City of West Linn
PRE-APPLICATION CONFERENCE MEETING
May 16, 2013

SUBJECT: Exterior remodel of historic landmark structure at 22820
Willamette Drive #6.

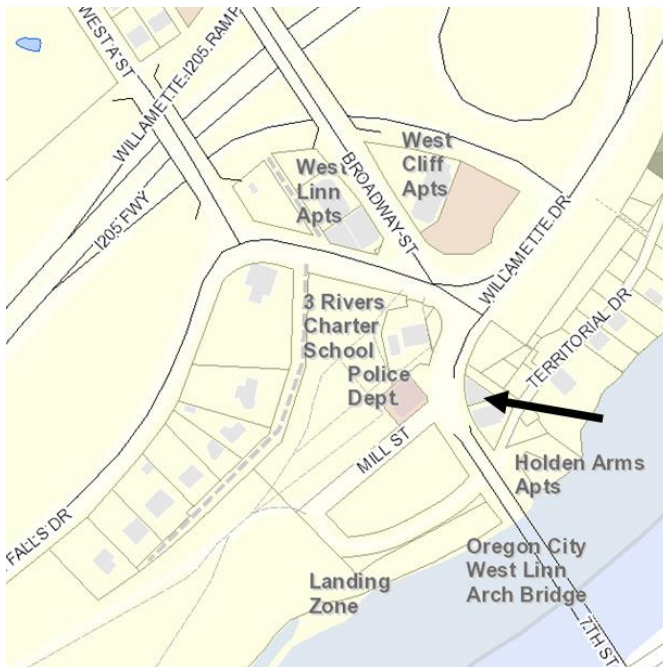
The applicant would like to make exterior changes to a portion (see arrow) of the mixed use building at 22820 Willamette Drive to increase its value as an office use. (The majority of the building is currently used for apartment rentals.) The applicant proposes to remove the wood/drivet that covers the pedestrian level windows, install pedestrian level windows, add a 6-8 foot deep awning, replace the door, and add a sign plus other changes to be more consistent with the original architecture. The building is listed as an historic landmark structure so any exterior modification requires a design review

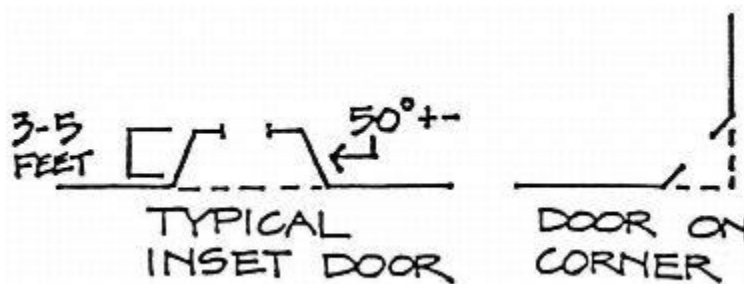
The proposal is to strip off the cladding on the pedestrian level window area and install appropriately sized windows (see option 1). Staff supports this proposal. Sloped aluminum or solid horizontal awnings, extending 6-8 feet from the building face, are proposed. Staff would support either option.
